UNITED STATES PATENT AND TRADEMARK OFFICE

APPLICATION NO.	FILING DATE	FIRST NAMED INVENTOR	ATTORNEY DOCKET NO.	CONFIRMATION NO.
10/642,413	08/15/2003	George Y. Huang	Huang/Cont Raised Port	3476
26860	7590	09/09/2004	EXAMINER	
LAW OFFICE OF DUNCAN PALMATIER 530 SOUTH ASBURY SUITE 5 MOSCOW, ID 83843			TSUKERMAN, LARISA Z	
			ART UNIT	PAPER NUMBER
			2833

Office Action Summary

DETAILED ACTION

Attachment 1

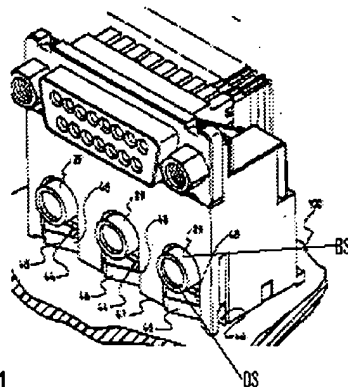
Claims 1 and 12 are rejected under 35 U.S.C. 102(b) as being anticipated by Tan et al. (5735699).

Tan et al. disclose the device 10 comprises the housing 16 with an outer surface and at least one end 20 adapted to hold an electrical connector plug, wherein the housing 16 has a raised portion 29 above the outer surface of the housing 16, a covering 12 formed over the outer surface of the housing 16 and around the raised portion 29, and an exposed part of the raised portion 29 is not covered by the covering 12 (see Fig. 3); the exposed part of the raised portion further comprises a background surface BS and a design surface DS, and the design surface is formed as part of the background surface and is not level with the background surface (see Attachment 1).

first of all, Tan et al. clearly discloses that the housing 16 has a raised portion 29 that is above the outer of the housing 16;

secondly, applicant's claim language is so broad and it does not clearly defined the "background surface" and the "design surface, further Applicant does not claim a "design surface providing a location for indicia", such as color, symbol, etc. Therefore, Examiner's interpretation thus any surface of the exposed part of the raised portion 29 would read as the "background surface" and the "design surface".
